SUNDRY NOTICES AND REPORTS ON WELLS
Do not use this form for proposals to drill or to re-enter an abandoned well. Use form 3160-3 (APD) for such proposals.

CHEVRON U.S.A. INC. INTENDS TO FRACTURE STIMULATE THIS WELL.

Skelly Unit 961

**Skelly Unit 961
30-015-34324
Chevron U.S.A. Inc.
May 16, 2013
Conditions of Approval**

Skelly Unit #961 Wellbore Diagram

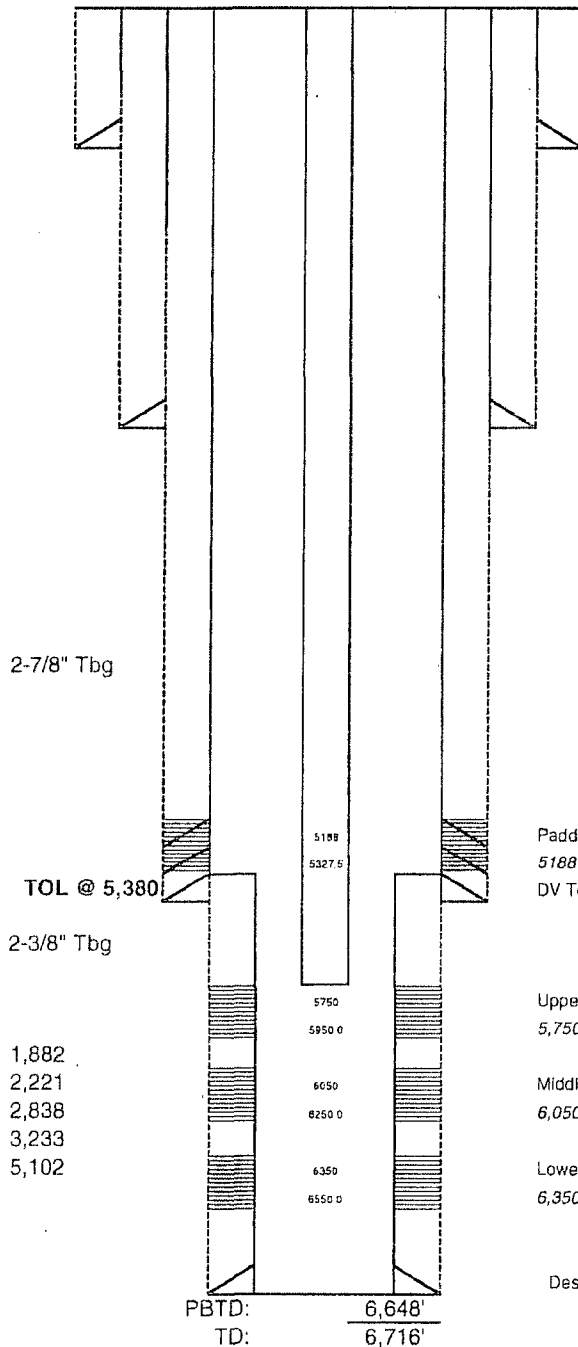
- 1. Must conduct a casing integrity test before any work can be done. Submit results to BLM. The CIT is to be performed on the 5-1/2" production casing per Onshore Oil and Gas Order 2.III.B.1.h.** Make arrangements 24 hours before the test for BLM to witness. E-mail Paul R. Swartz pswartz@blm.gov or phone 575-200-7902, if there is no response, 575-361-2822. If no answer, leave a voice mail or email with the API#, workover purpose, and a call back phone number. Note the contact, time, & date in your subsequent report.

- 2. If CIT does not fail work is approved as proposed by operator.**
3. Before casing or a liner is added or replaced, prior BLM approval of the design is required. Use notice of intent Form 3160-5.
